UNITED STATES PATENT AND TRADEMARK OFFICE

APPLICATION NO.	FILING DATE	FIRST NAMED INVENTOR	ATTORNEY DOCKET NO.	CONFIRMATION NO.
10/721,233	11/26/2003	Yoshiyuki Katoh	019970-010	5685

Office Action Summary

DETAILED ACTION

Fig. 4

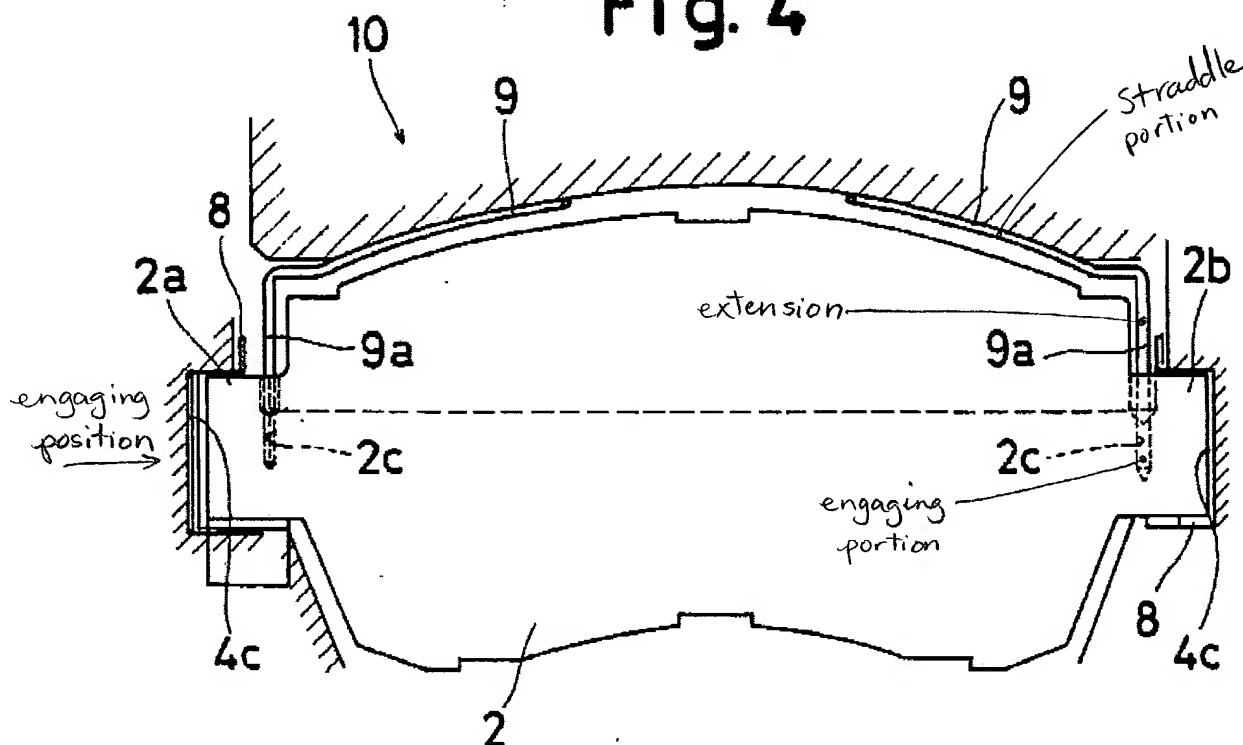
Re: claim 1, Tsuruta shows a disk brake assembly, as in the present invention, comprising: a disk rotor 1 having a central axis; a pair of friction pads 2,3 arranged and constructed to be pressed against the disk rotor from opposing sides in an axial

direction of the disk rotor and a return spring 9 coupled to the friction pads and arranged and constructed to bias the friction pads in directions away from the disk rotor, wherein: the return spring includes a straddle portion, a pair of extensions and a pair of engaging portions, as indicated on the figure below, the straddle portion is disposed radially outside of the disk rotor and extends in the axial direction across the thickness of the disk rotor in order to straddle the disk rotor, each of the extensions extends from the straddle portion, in a direction substantially toward the central axis of the disk rotor, to an engaging position that is proximate to a centerline of one of the friction pads with respect to a radial direction of the disk rotor; each of the engaging portions is disposed at one end of each extension and engages one of the friction pads at the engaging position, as shown in the figure below.

Re: claim 10, figure 4 shows the extensions located in a gap between the mount and the ends of the friction pads.

Re: claim 19, Tsuruta shows in figure 4 the joint portions to be located proximal to a central line of the friction pads.

Re: claim 20, figure 4 shows the extensions extends and contact the friction pads as claimed.
